10-2016 LATEST REVISION DATE	 APPROVED BY BRIDGE ENGINEER	 STANDARD DESIGN - 40' ROADWAY, 3 SPAN BRIDGES <b>ROLLED STEEL BEAM BRIDGES</b> JUNE, 2010	<b>FRAMING PLAN</b> <b>220'-0 BRIDGE</b>	<b>RS40-047-10</b>

0° SKEW FRAMING PLAN

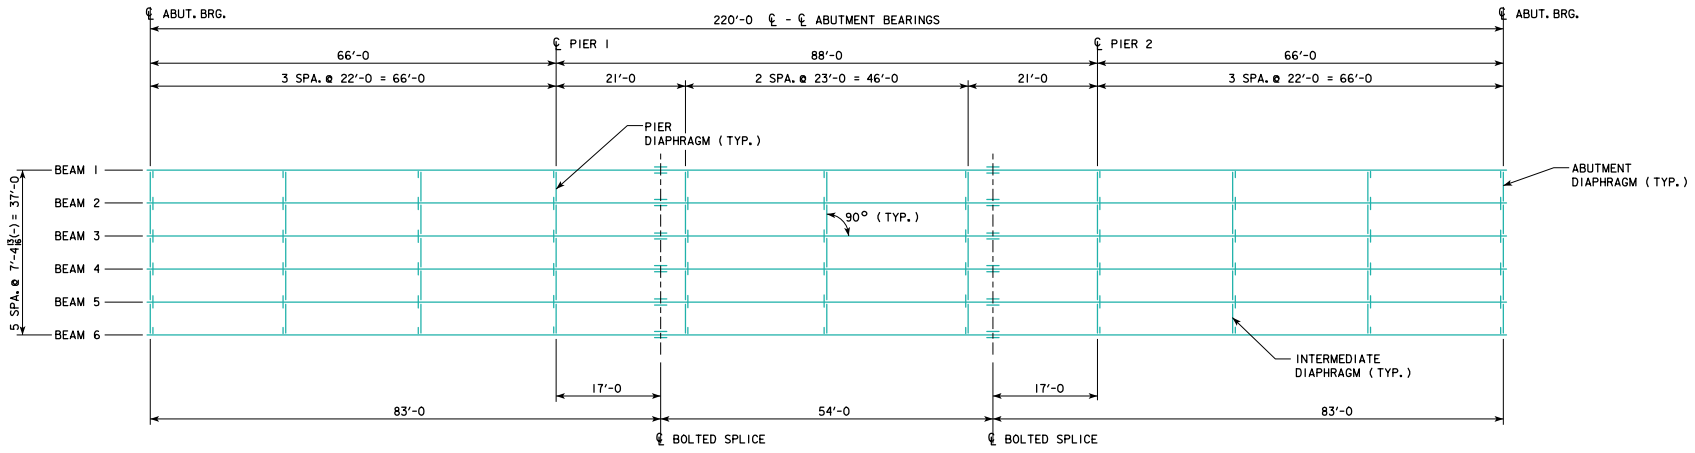
REVISED 10-2016 - CHANGED DIAPHRAGM SPACING IN ZERO SKEW FRAMING PLAN (WAS 4 SPACED AT 22'-0") IN 88'-0" CENTER SPAN, CHANGED DIAPHRAGM SPACING IN SKEWED FRAMING PLAN (WAS 4 SPACED AT 22'-0") IN 88'-0" CENTER SPAN, ADDED DIAPHRAGMS TO SKEWED FRAMING PLAN IN OUTER BAYS, BETWEEN BEAMS 1 & 2 AND 5 & 6 OF 88'-0" CENTER SPAN, 11'-0" FROM PIER CENTERLINES.
